Project: Front Range Passenger Rail Service Development Plan and National Environmental Policy Act (NEPA)

From: FRPR Project Development Subcommittee

Subject: FRPR Scenario (Alignment) Design Options + Technology Considerations

Figure 1. Fort Collins Bypass via 392 shown in purple.

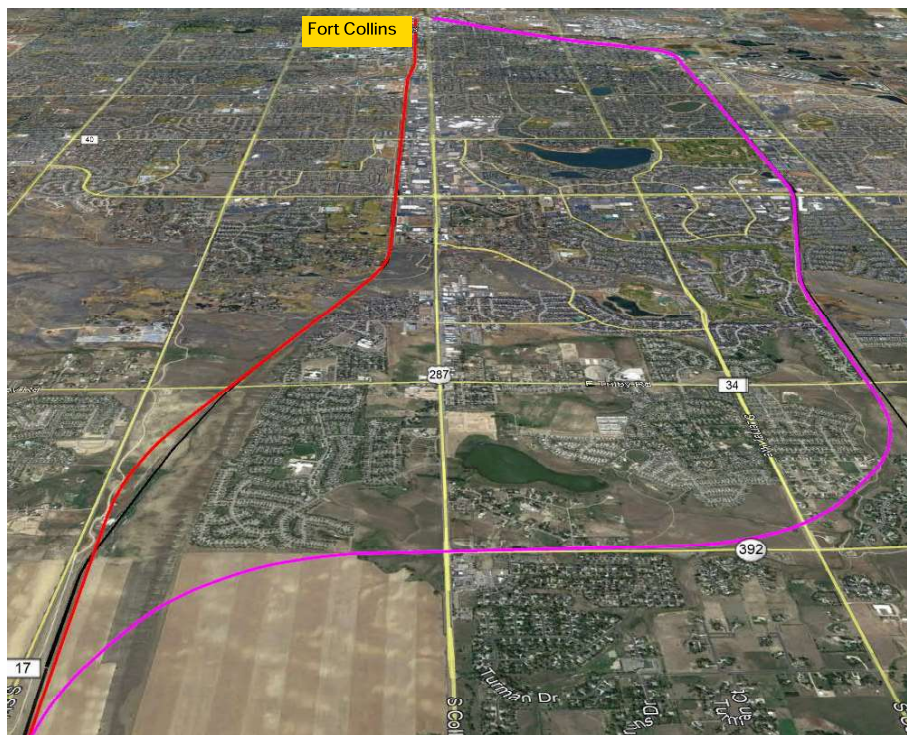
Fort Collins Bypass 392 to UP/GWR – shifts path to Ft Collins eastward (purple in Figure 1 below) from a constrained BNSF/Mason St corridor to UP and then GWR corridors into the preferred downtown Ft Collins station location. From stakeholder input, this bypass may be preferred and is a feasible option to avoid further Mason St disturbance for construction and operations through the heart of Fort Collins. Crossing from 392 to the UP/GWR corridor would present the following challenges:

- 1-2 residential property takings.
- Approximately 0.5 miles of aerial structure to fly over Fossil Creek/Wetlands with limited disturbance.
- Approximately 3 miles of added route distance from the current Alternative 3 and 4 North segment.

Figure 4. Alternative 3 US 36 Design option shown in teal.

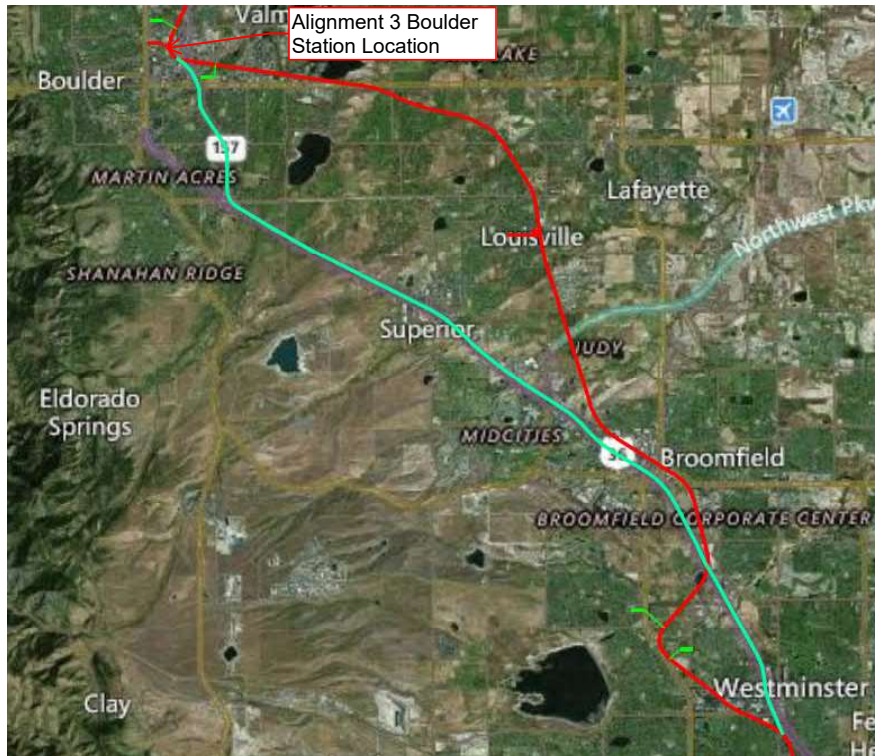
Alternative 3 US36 Design Option – This option presents an alternate transportation corridor into Boulder.

- Horizontal geometry is more favorable (higher speeds are achievable)
- Reduces the total route distance from Denver Union Station to Boulder by 2 miles.
- The vertical grades would require further study to confirm if 3% or less could be maintained throughout this alignment with cost-efficient building methods. The grade of US 36 about 1 mile west of Marshall Road poses the biggest challenge.
- Significantly less freight interaction/civil speed restrictions.
- Fewer crossings overall (at-grade, overpass, or underpass) but this option would require more major viaduct structure to flyover US36 interchanges.

Figure 5. Plum creek avoidance alignment shown in green.

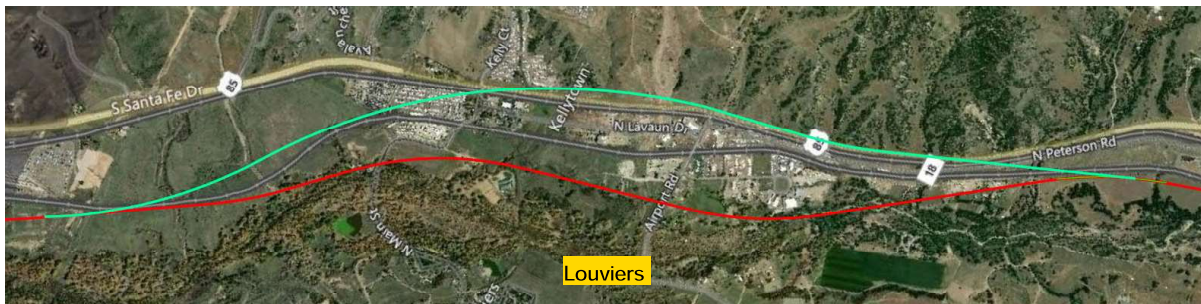
Alternative 3/4 Plum Creek Avoidance Option –

- Shifts Alternative 3 and 4 Central Segment to US 85 corridor for about 2 miles.
- Avoids significant impact and major structures out of Plum Creek / Wetlands + residential/farmland.
- Adds 2 US 85 crossovers/freight rail overpasses.

Figure 6. Carpenter creek/freight avoidance alignment shown in green.

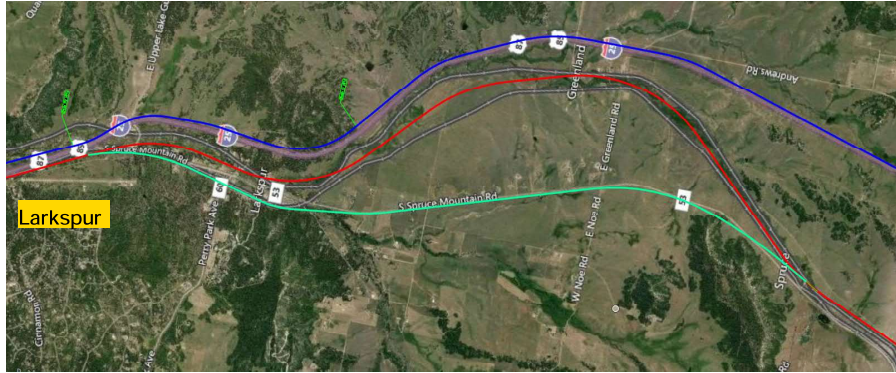
Alternative 3/4 Carpenter Creek/Freight Avoidance –

- Shifts Alt. 3/4 South Segment out of Carpenter Creek/Wetlands which runs between two existing freight lines
- Avoids significant environmental impact and structures to traverse Carpenter Creek area
- Shorter alignment distance than current geometry
- Originally ruled out due to suspected grade challenges, preliminary google earth vertical profile shows less than 3% grades along Spruce Mountain Rd

Figure 8. Alternative 6 North Segment to North Metro Station (blue) plus Alternative 4 North Segment from North metro to Fort Collins.

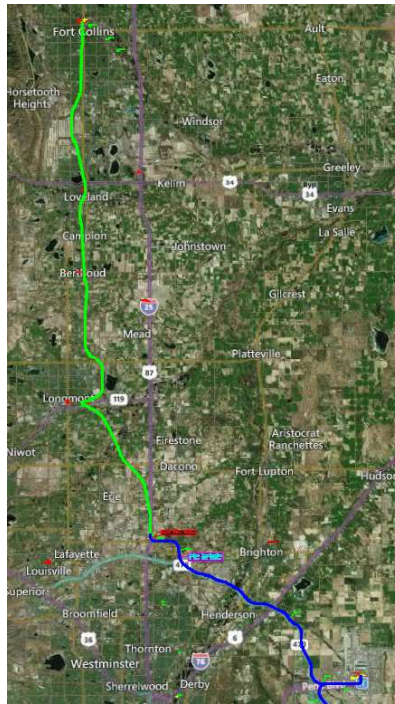
- **Alt 6 + Alt 4 after North Metro Station** – this hybrid alternative would follow the Alternative 6 North segment but switch to Alternative 4 at North Metro station. This option presents a potentially higher ridership capture than current design Alternative 6 as the Longmont and Loveland population centers would be accessed instead of stations along N I-25. However, the current I-25 north alignment is shorter and allows faster runtimes.

Figure 9. Alternatives 3/4 (red & green) plus Alternative 6 South Segment (blue).

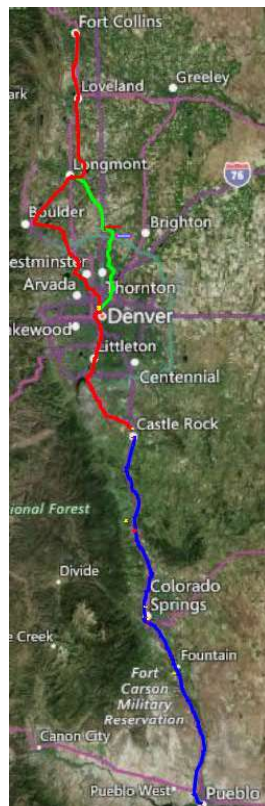
- **Alts 3/4 + Alt 6 South Segment** – this hybrid alternative would utilize the Alternatives 3/4 North and Central segments and then use the Alternative 6 South segment, which performed more favorably in runtime and cost modelling.

Alternative 3 -North Segment

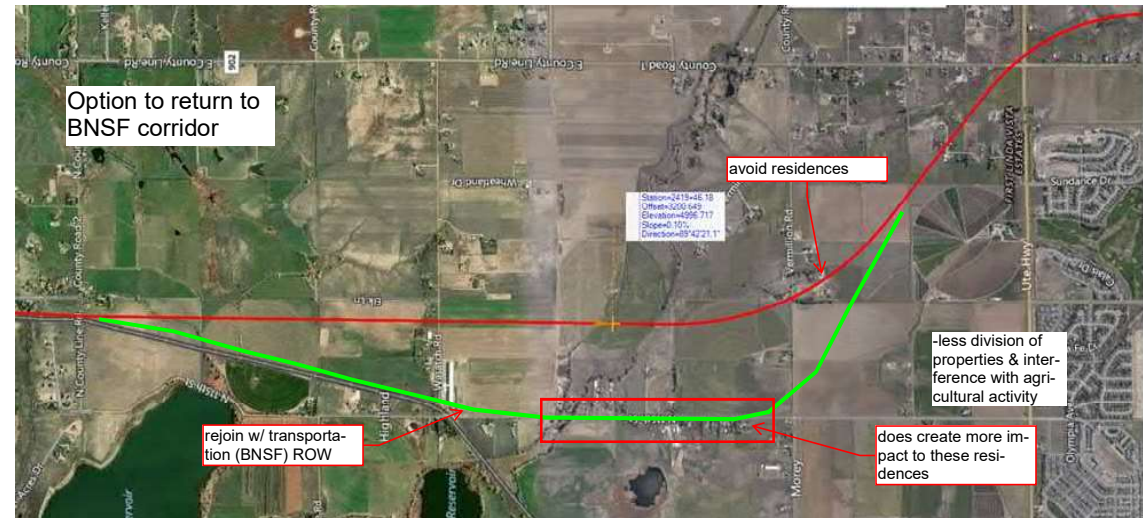
Option for bypass in Longmont

potential location for maintenance facility

tangent extended - avoids golf course

US 36 Option

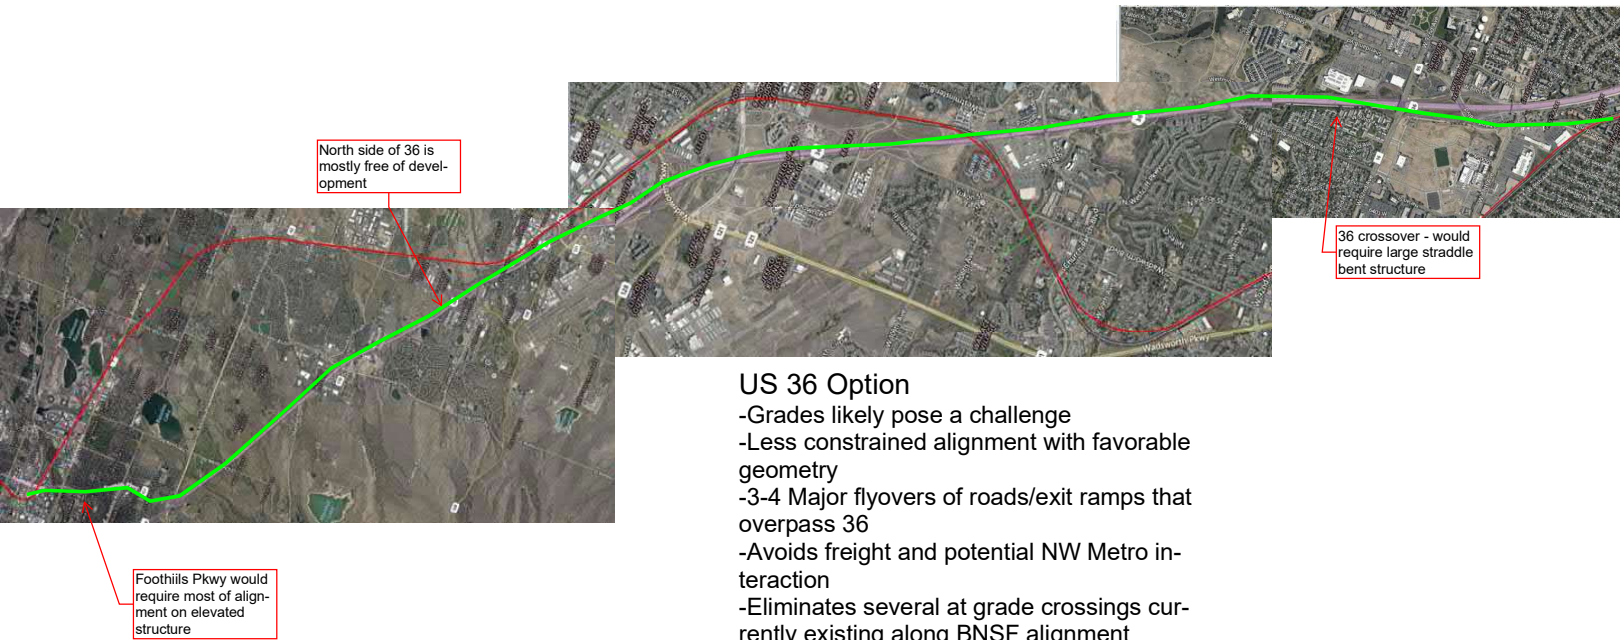
Potentially avoids Fox Hill Country Club, less at grade crossings, retrofitting complex underpass. Introduces slow curve but proximate to station slow down area

- Grades likely pose a challenge
- Less constrained alignment with favorable geometry
- 3-4 Major flyovers of roads/exit ramps that overpass 36
- Avoids freight and potential NW Metro interaction
- Eliminates several at grade crossings currently existing along BNSF alignment

*** BNSF ROW width is limited - fitting freight and passenger service(s) (with separate trackage to maintain design speeds) would be a challenge in many sections. Freight and FRPR could share trackage, which presents another set of challenges with track design, sidings, station stops, etc. That potential interaction would affect travel time modeling. Having another option into Boulder could be prudent. Benefits of US36 include potential for higher speed operation (less curvature) , less development and impact surrounding the corridor (compared to Louisville).

Alternative 3 - Central Segment

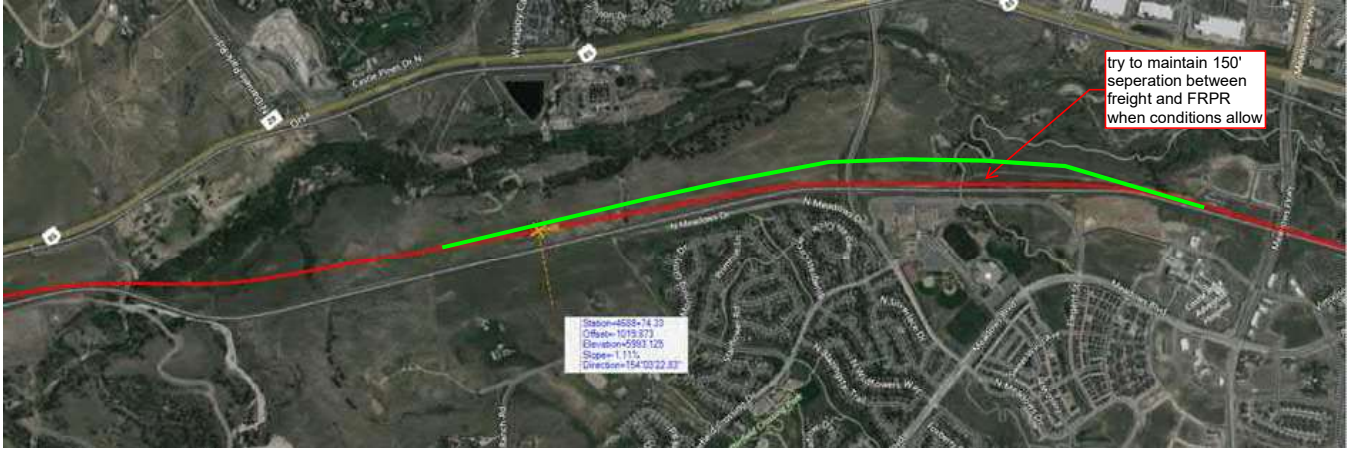
Option for East side of 85 (but adds 2 major crossovers) - hugging freight ROW like original Alt. 3 also less impactful

try to maintain 150' separation between freight and FRPR when conditions allow

Alternative 3 - South Segment

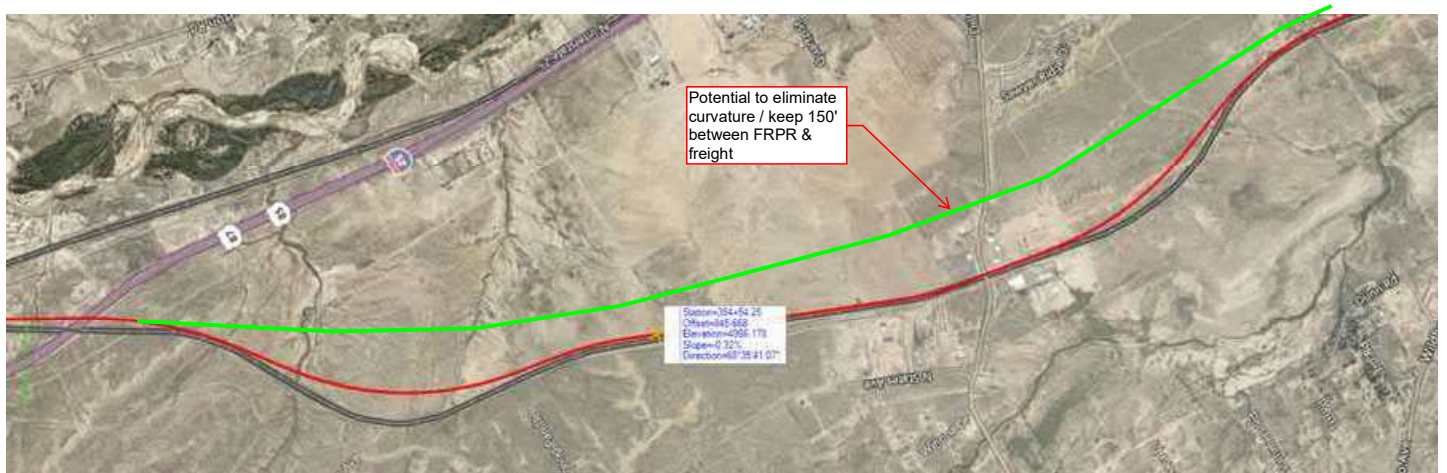
Option for avoidance of neighborhood in Monument

NEPA process will likely push this section back into freight ROW with suboptimal curve

Alt 4 Option 1b

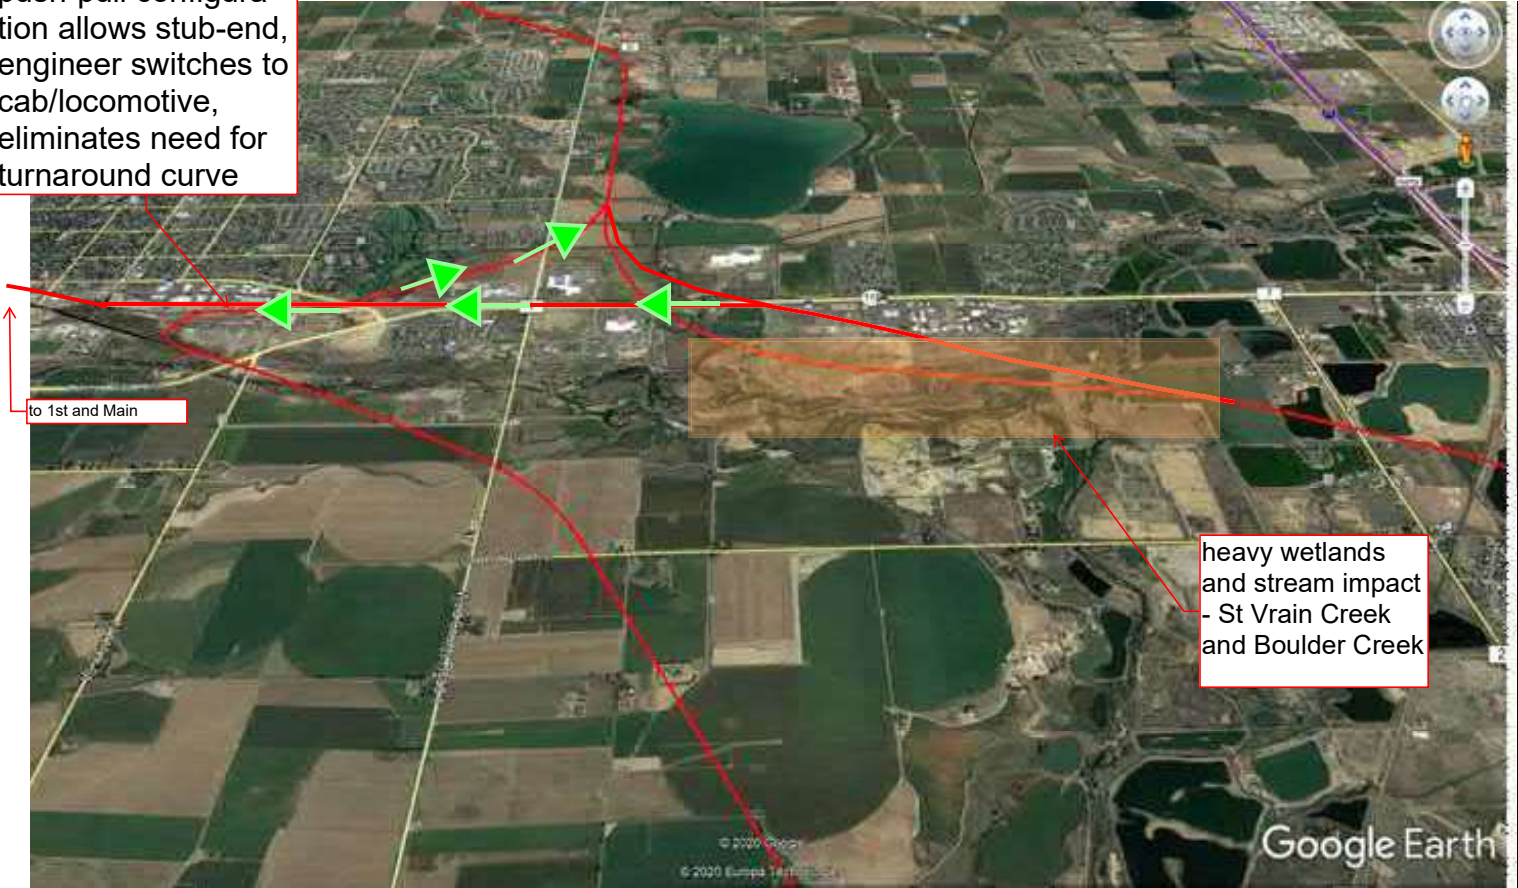
push-pull configuration allows stub-end, engineer switches to cab/locomotive, eliminates need for turnaround curve

to 1st and Main

heavy wetlands and stream impact - St Vrain Creek and Boulder Creek

Alternatives 4,5,6

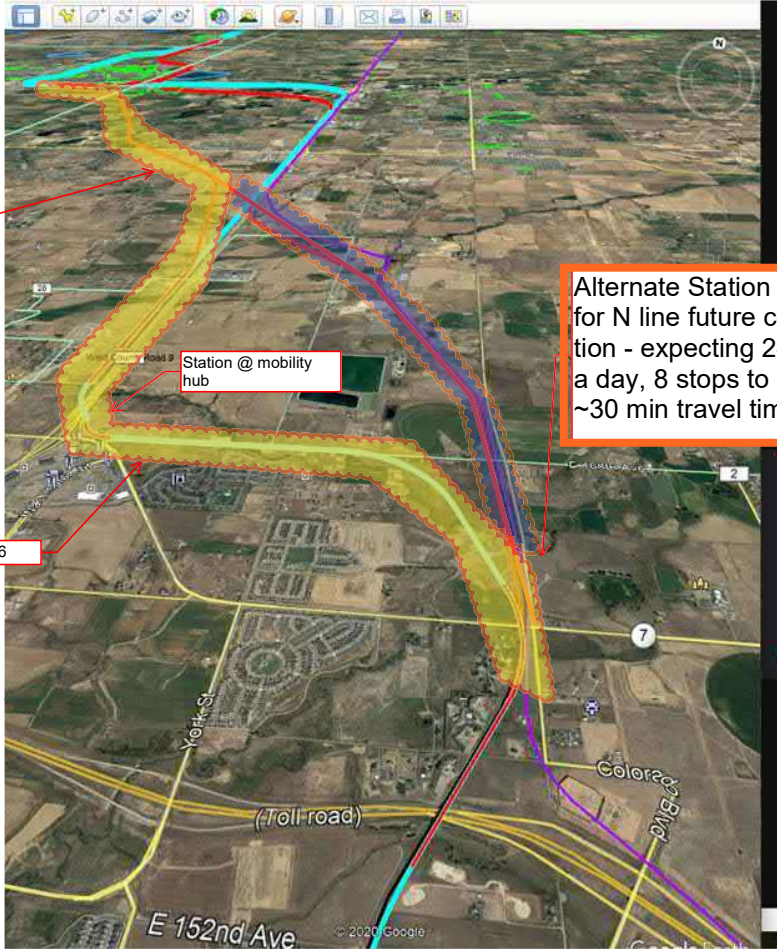
Alternate Station - EOL for N line future construction - expecting 24k riders a day, 8 stops to DUS, ~30 min travel time

Alternative 6 - Central Segment Suggested Avoidances

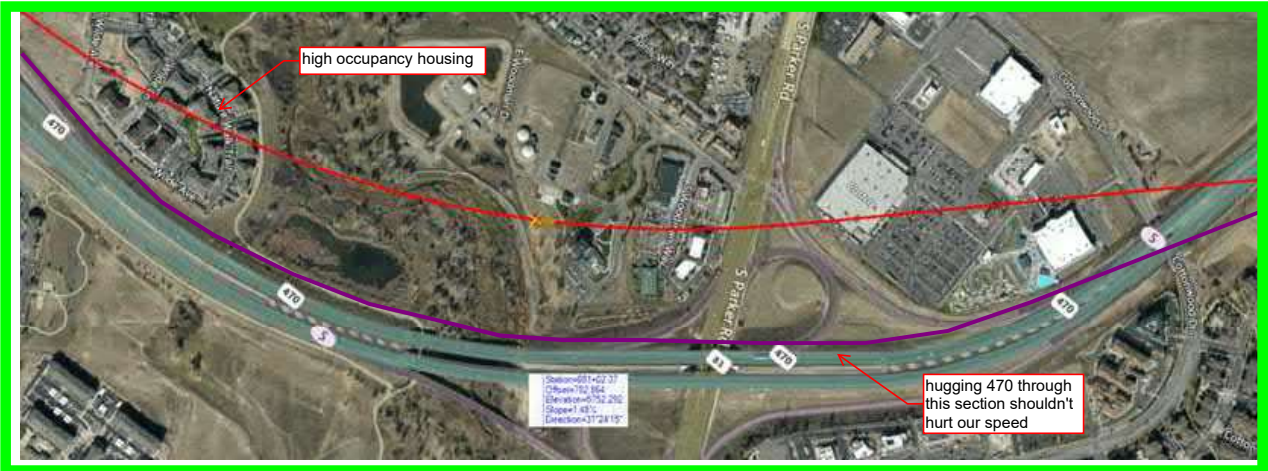
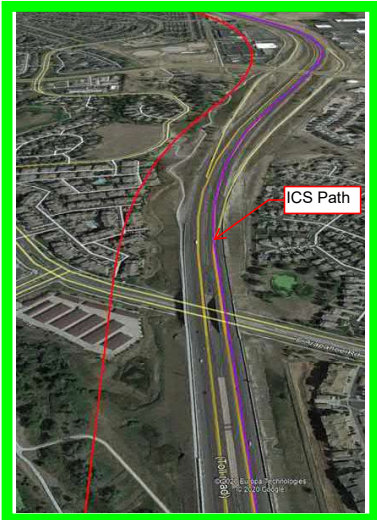
South/East side of 470 much less impactful through these sections Stations 1043+00 - 1275+00

Design Recommendation Accepted
and Incorporated prior to Level 2 Mod-
elling

Alternative 6 - North Segment Suggested Avoidances

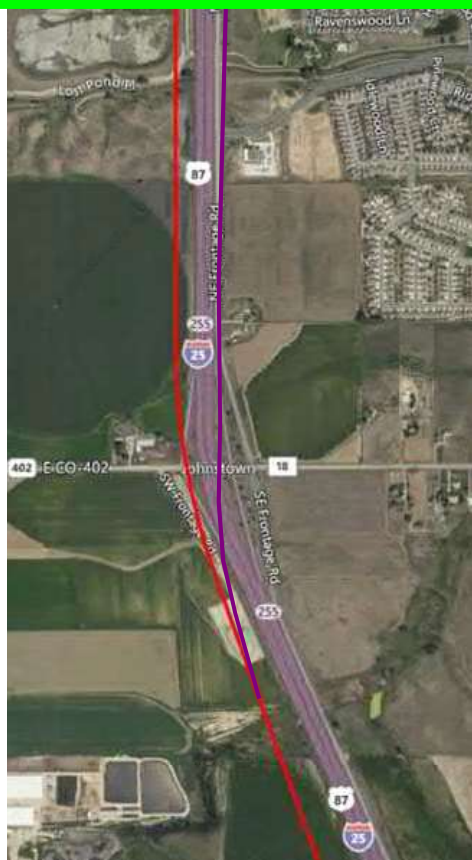
Potential for Crossover at SR18 -
-North of this point the east side of I-25 is much less impactful (all images on previous page)
-Generally, the tighter to I-25, the better on either side
